Addendum	01
Date:	July 28 th , 2026
Project:	KGCC – Clubhouse 2026-01
Address:	777 Clonsilla Av. Peterborough, On

1 INTENT

4. ARCHITECTURAL DRAWINGS

A0.00

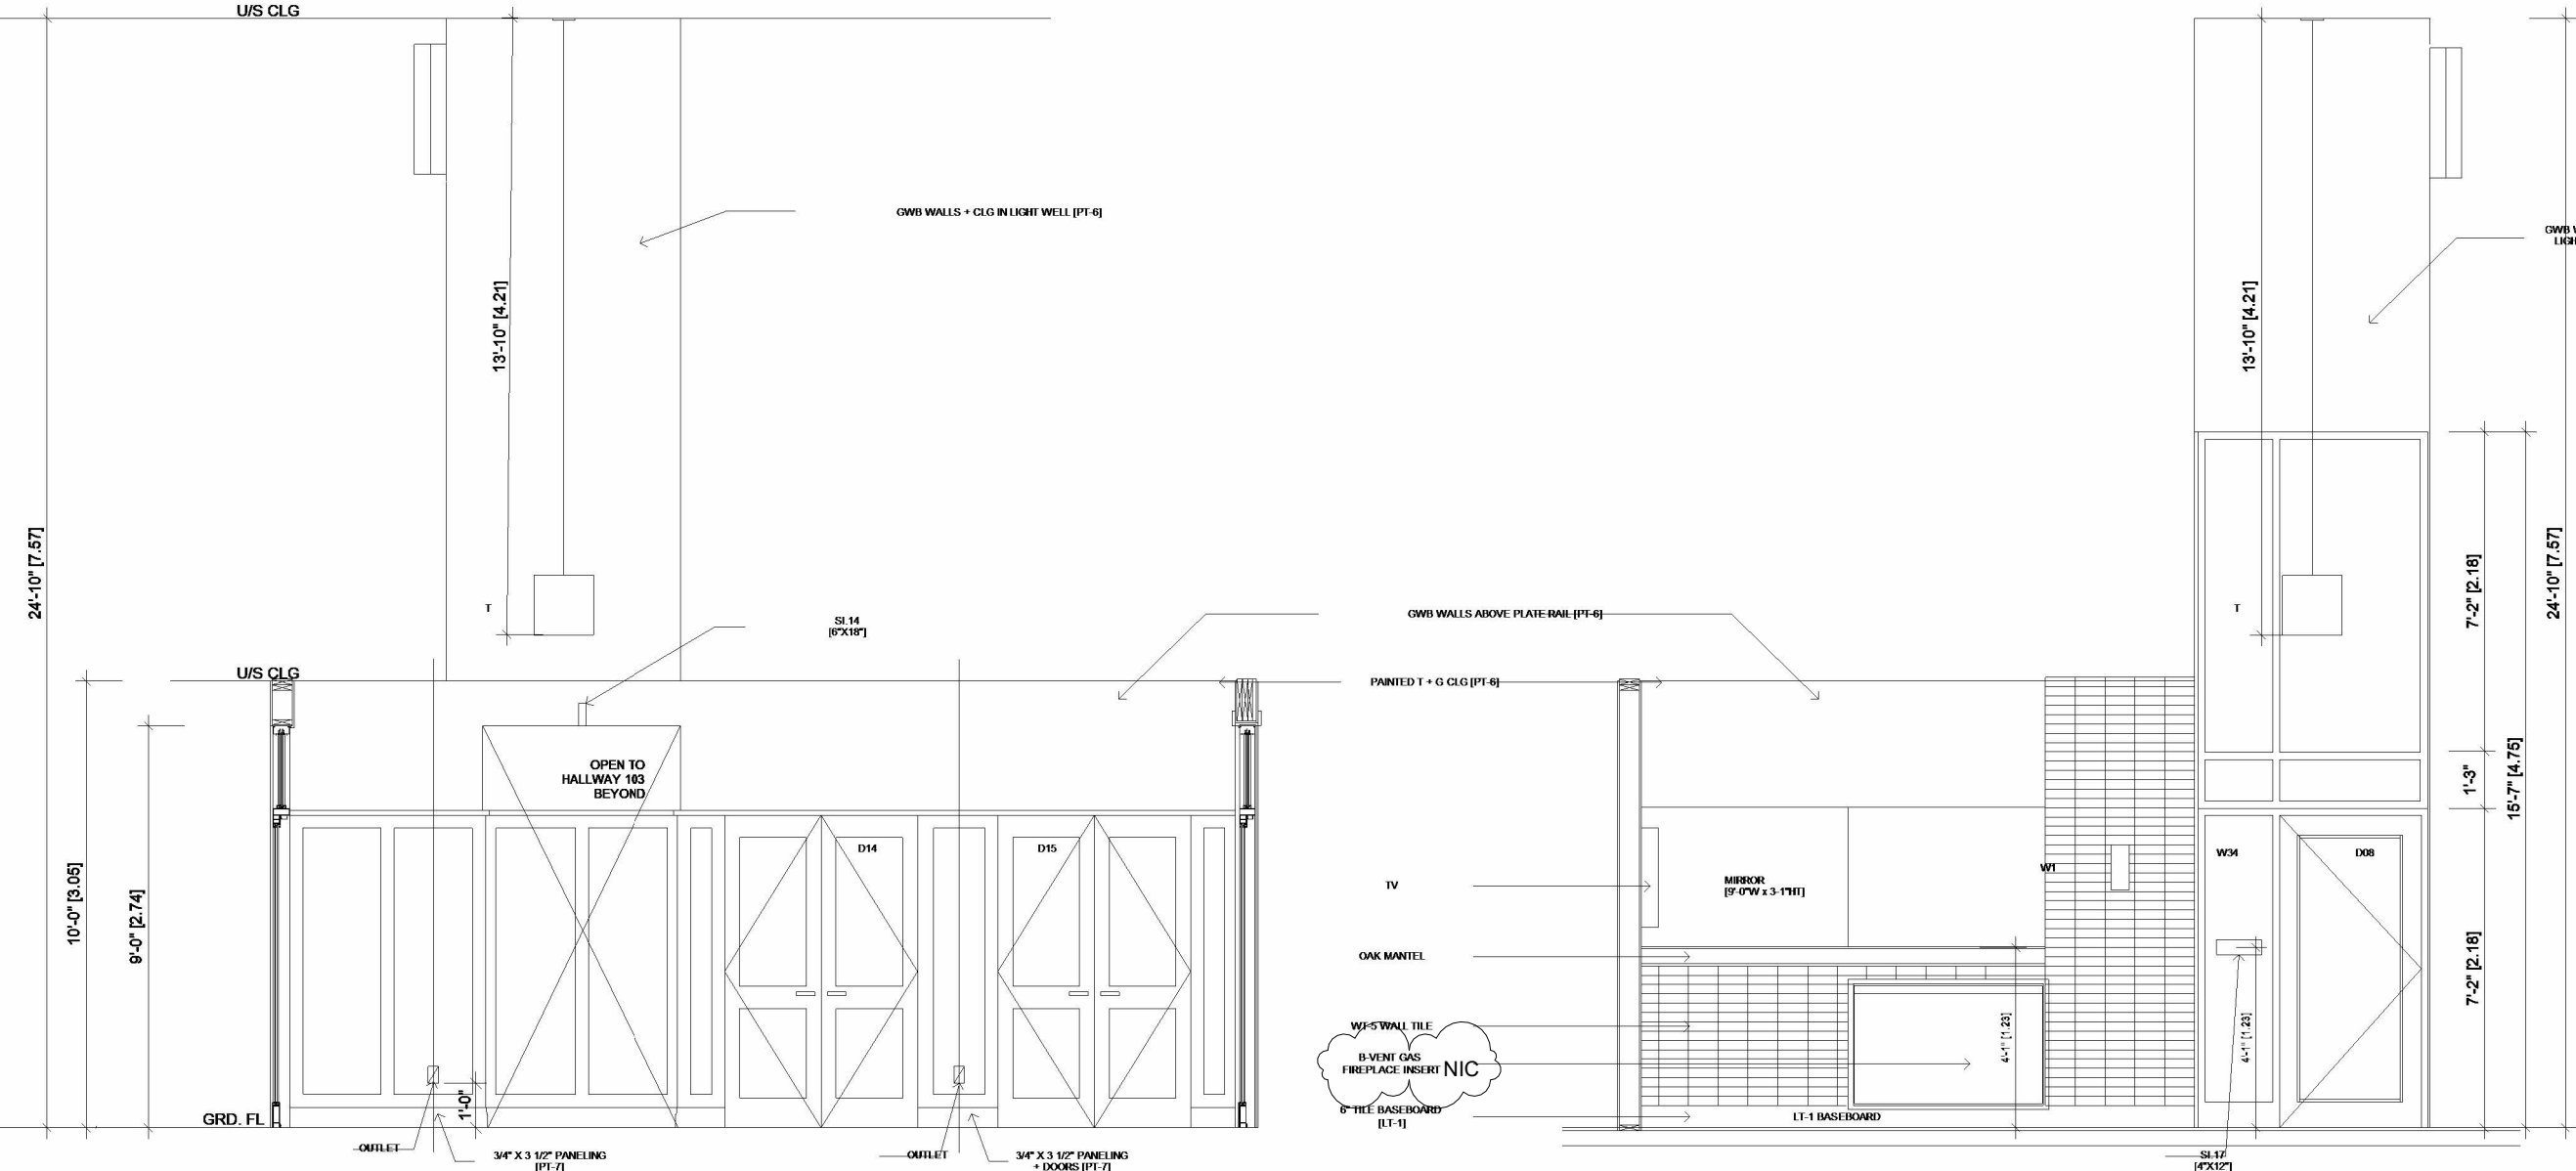
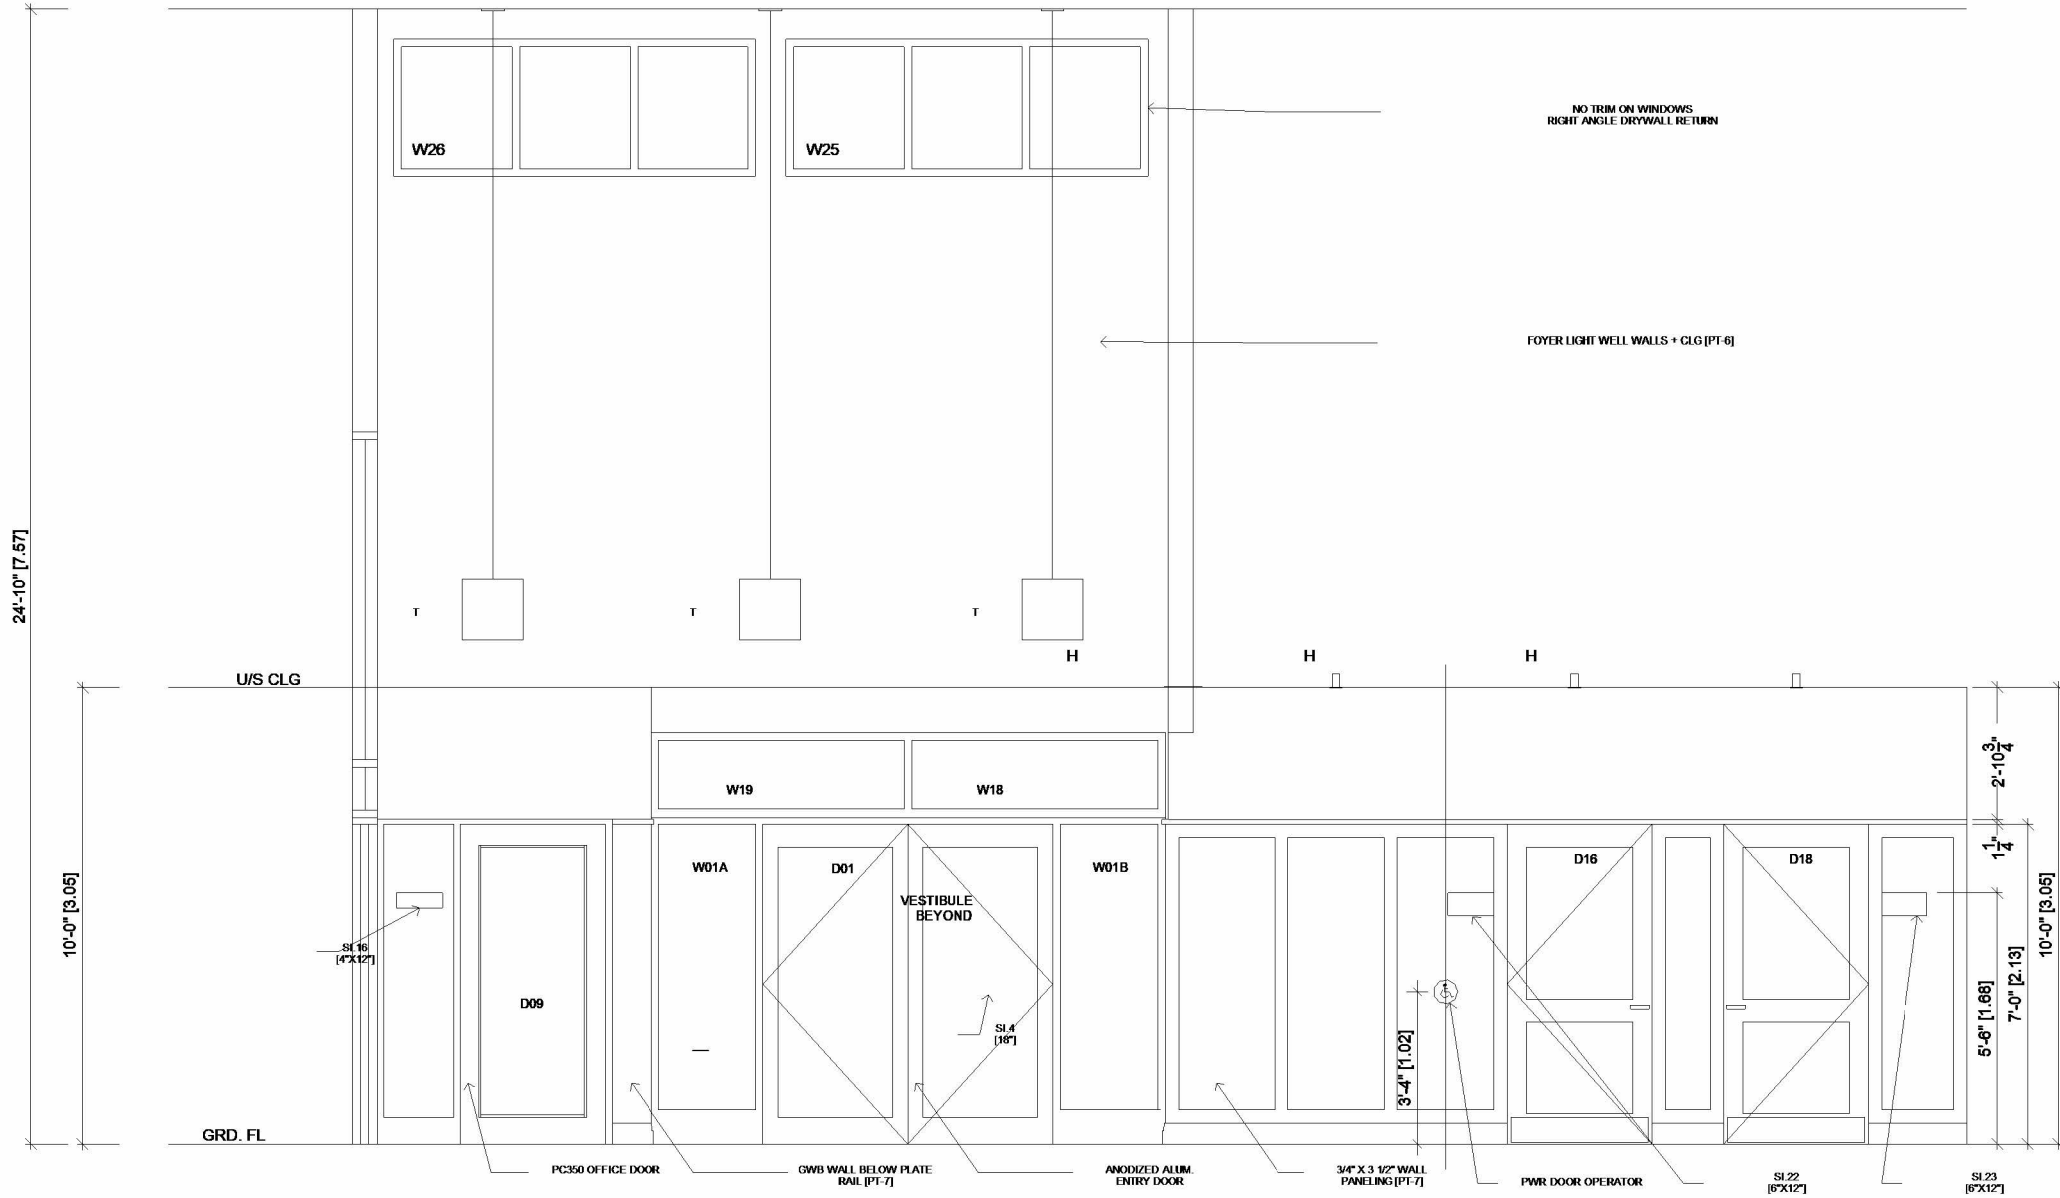
4.1. DRAWING NO. A0.00 R3

4.1.1. Edited contact details for Structural Consultant.

A6.01

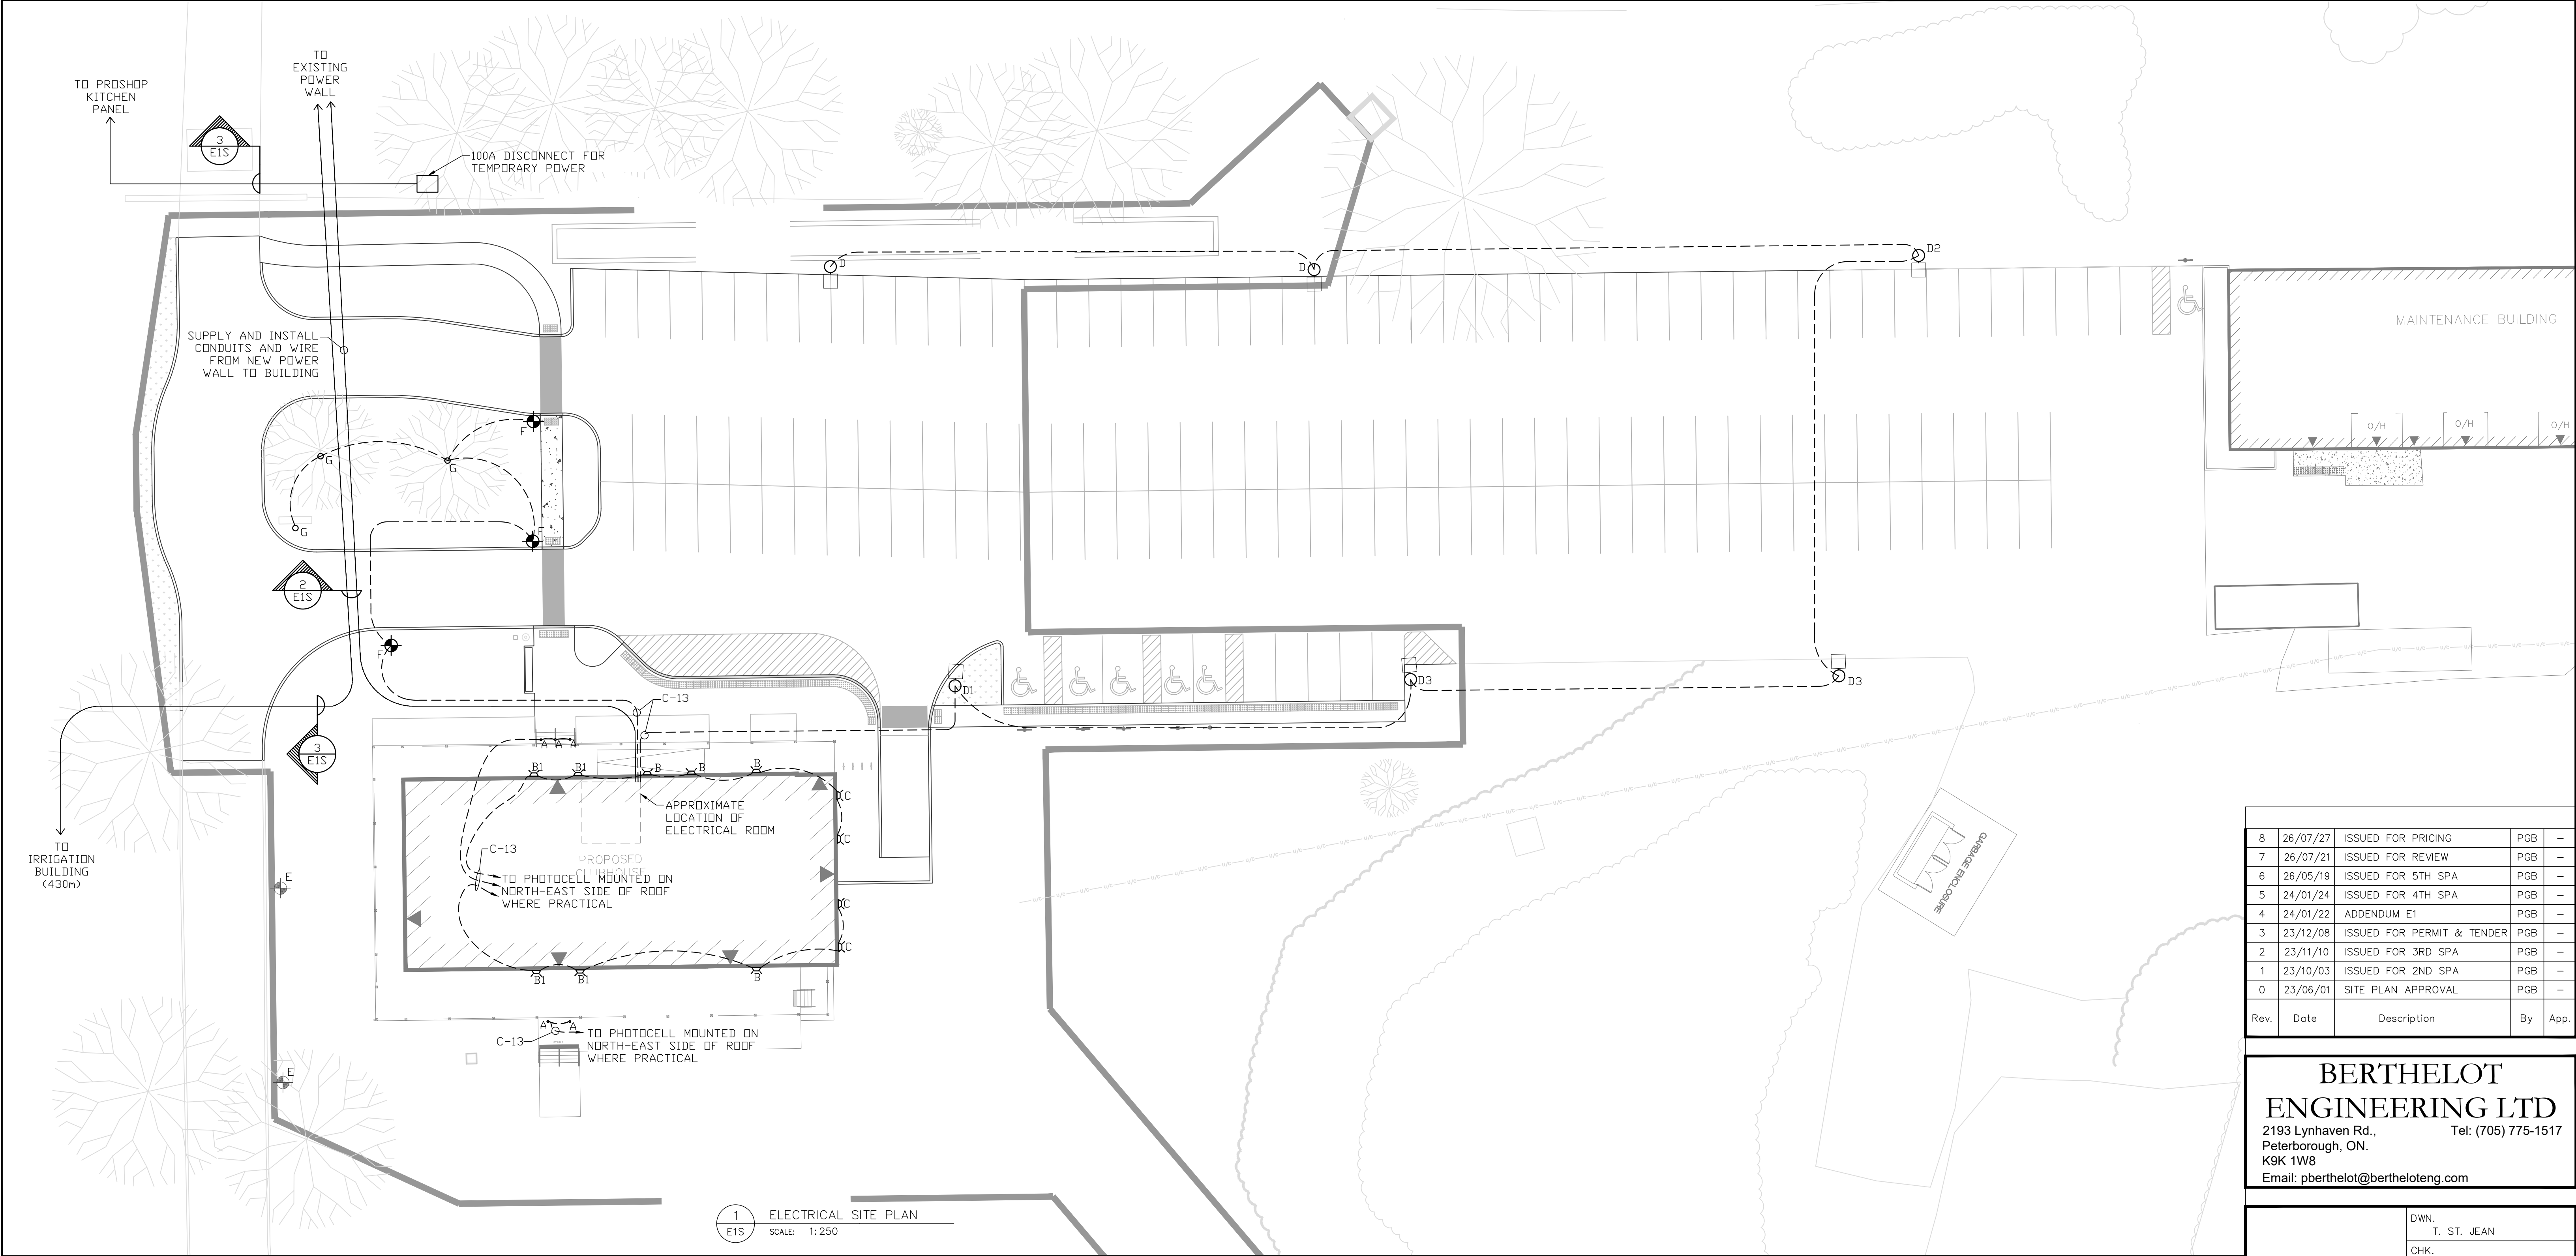
- 2.5 Please do Not include for any type of fireplace in foyer on drawing A6.01 at this time.
- 2.6 Revised deadline for questions and extended submission deadline date, see table below.

4.2. DRAWING NO. A6.01 R2 & A5.09 R2

4.2.1 REMOVE fireplace insert from contract. ONLY.
